TMS320C6201
Digital Signal Processor
Silicon Errata

SPRZ153
November 2000

Figure 2. SBSRAM Read Timing (1/2 Rate SSCLK) (See Note)

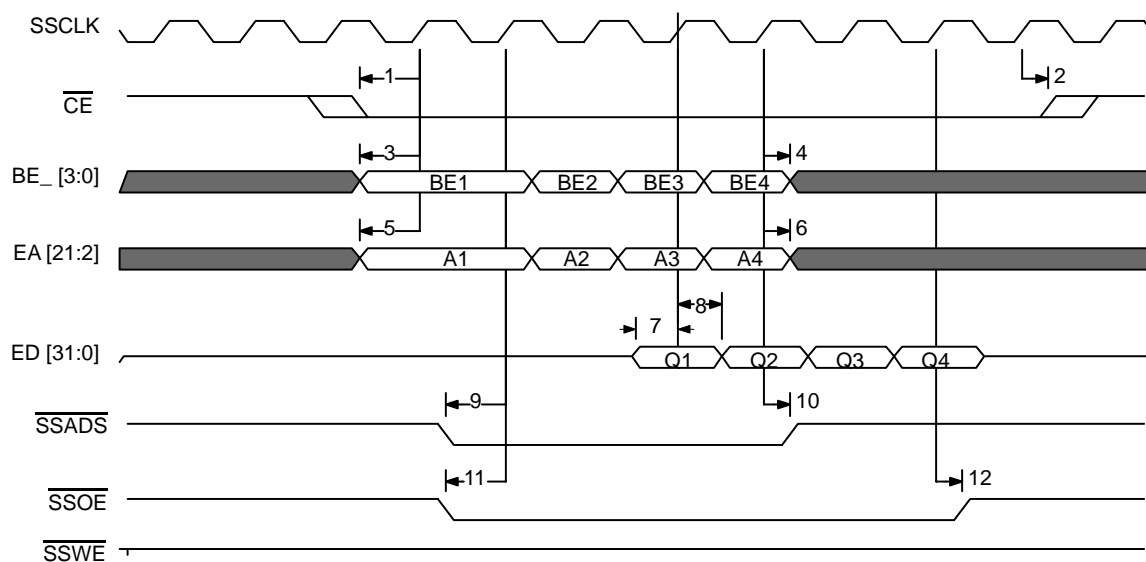
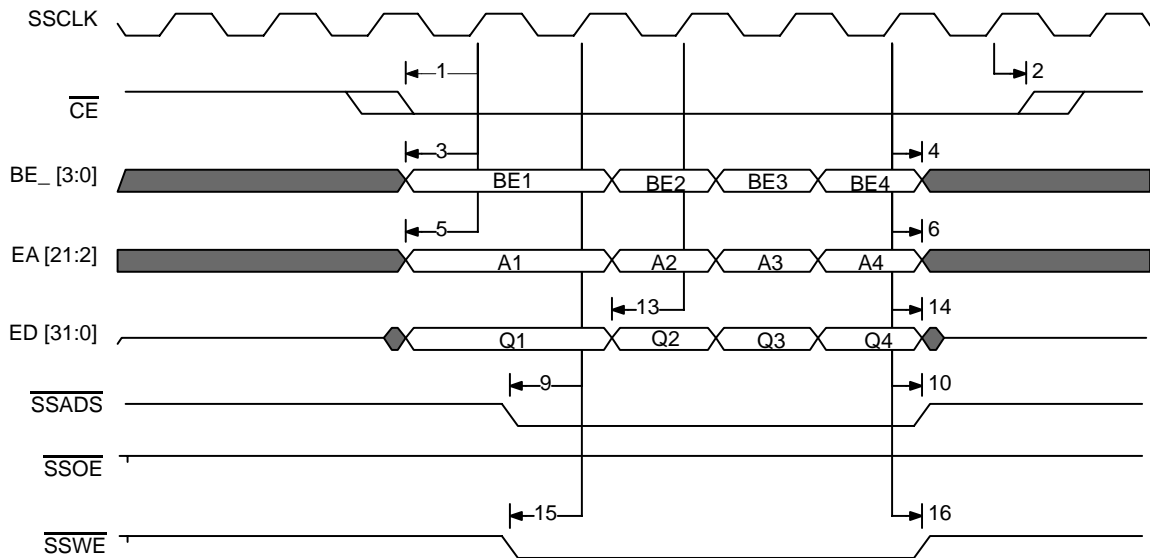
2 Changes to the TMS320C6201 Data Sheet (literature number SPRS051)

NOTE: The $\overline{\text{CE}}$ output setup and hold times are specified to be accurate relative to the clock cycle to which they are referenced, since these timings are specified as minimums. However, the $\overline{\text{CE}}$ output setup and hold time may be greater than that shown in the data sheet in multiples of P ns. In other words, for output setup time, the $\overline{\text{CE}}$ transition from high to low may happen P, 2P, ..., or nP ns before the time specified by the data sheet. Similarly, for output hold time, the $\overline{\text{CE}}$ low-to-high transition may happen P, 2P, ..., or nP ns after the time specified by the data sheet. This is indicated by the period of uncertainty for specs 1 and 2 in Figure 2, and Figure 3.

Figure 4. Write Example – Desired Behavior

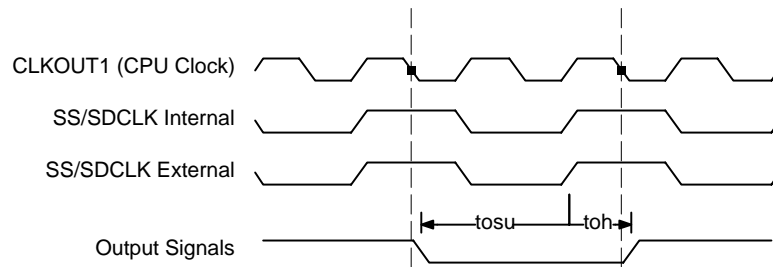
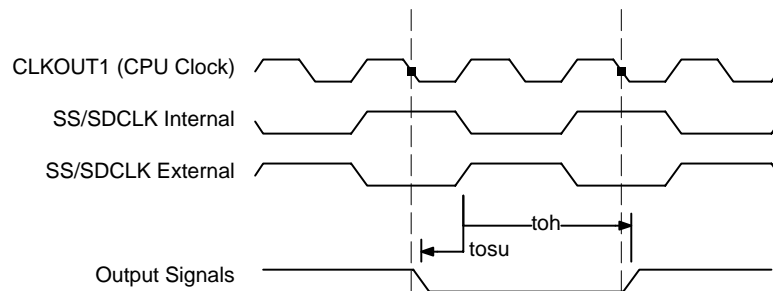
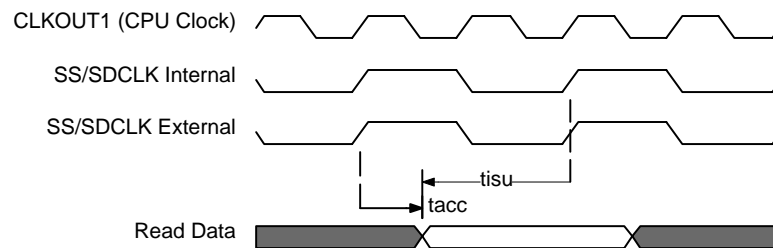
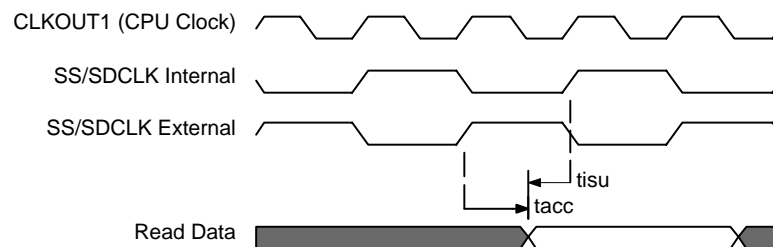
A speedpath in the device causes SDCLK and SSCLK to start up 180 degrees out-of-phase (effectively inverted) from the desired waveform. Normally, EMIF outputs are delayed 1/2 CPU clock from the rising edge of SDCLK/SSCLK to give it adequate hold time while maintaining more than adequate setup times.

The desired relationship is described in the TMS320C6201B data sheet (SPRS051) and is illustrated in Figure 4 and Figure 6. However, in the case where SDCLK/SSCLK becomes inverted (Figure 5 and Figure 7), control signals only have 1/2 CPU clock of setup to the next SDCLK/SSCLK rising rather than 3/2 CPU clock of setup. This has two negative effects to interface timing to external synchronous RAMs.

1. On writes, setup time to RAMs for control signals and write data is reduced by 1 CPU cycle.

- For prototypes, raising the core supply to 1.9 – 2.1 V corrects this problem. This is not recommended in boards shipped to customers, since the manufacturing process is not designed to be reliable outside the normal operating range. This option allows the user to verify current board designs at all valid frequency ranges.

- Reduce the operating frequency of the TMS320C6201B until SSCLK/SDCLK has the desired relationship. Typically, this occurs at 175 MHz across the range of recommended operating conditions.

- Since SSCLK and SDCLK are inverted externally relative to each other by design, these signals can be swapped on external memory interfaces to correct the problem (SSCLK to SDRAM and SDCLK to SBSRAM). This will cause invalid operation at frequencies below 175 MHz and will not work with future silicon revisions.
